Project	IEEE 802.16 Broadband Wireless Access Working Group < http://ieee802.org/16 >
Title	Figure Change
Date Submitted	2007-01-1518
Source(s)	Peretz Feder, Honghai Zhang ALU pfeder@alcatel-lucent.com , hozhang@alcatel-lucent.com Pbarber@huawei.com
Re:	
Abstract	<u>Additional Hand over primitives for Mobile Side</u>
Purpose	Adoption
Notice	This document has been prepared to assist IEEE 802.16. It is offered as a basis for discussion and is not binding on the contributing individual(s) or organization(s). The material in this document is subject to change in form and content after further study. The contributor(s) reserve(s) the right to add, amend or withdraw material contained herein.
Release	The contributor grants a free, irrevocable license to the IEEE to incorporate material contained in this contribution, and any modifications thereof, in the creation of an IEEE Standards publication; to copyright in the IEEE's name any IEEE Standards publication even though it may include portions of this contribution; and at the IEEE's sole discretion to permit others to reproduce in whole or in part the resulting IEEE Standards publication. The contributor also acknowledges and accepts tha

Figure xxx – Primitive flow between NCMS at the MS and the MS when HO is initiated

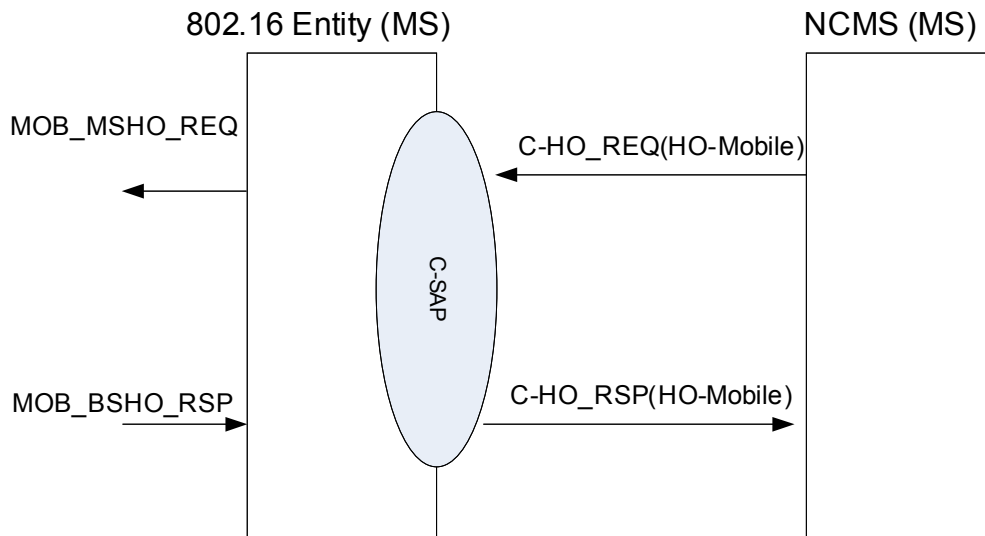
8 The 802.16g draft is missing the trigger for Mobile Initiated Handover. When the NCMS
9 at the MS decides to initiate a handover (as opposed to HO-Start) with the Serving BS it
10 informs the 802.16 MS entity to send a MOB_MSHO-REQ listing the candidate BS for
11 an upcoming HO-Start or HO-Cancel.

7 **14.2.5.2.1.5 C-HO-RSP (Action_Type==HO-Mobile)**

9 This primitive is used by the MS to inform the Mobility Management Services entity in the NCMS MS about the
 10 arrival of a MOB-BSHO_RSP MAC message in response to the previously generated MOB_MSHO-REQ
 11 message and the pruned down list of the candidate BSs selected by the Mobility Management in the NCMS for
 12 the upcoming actual HO phase.
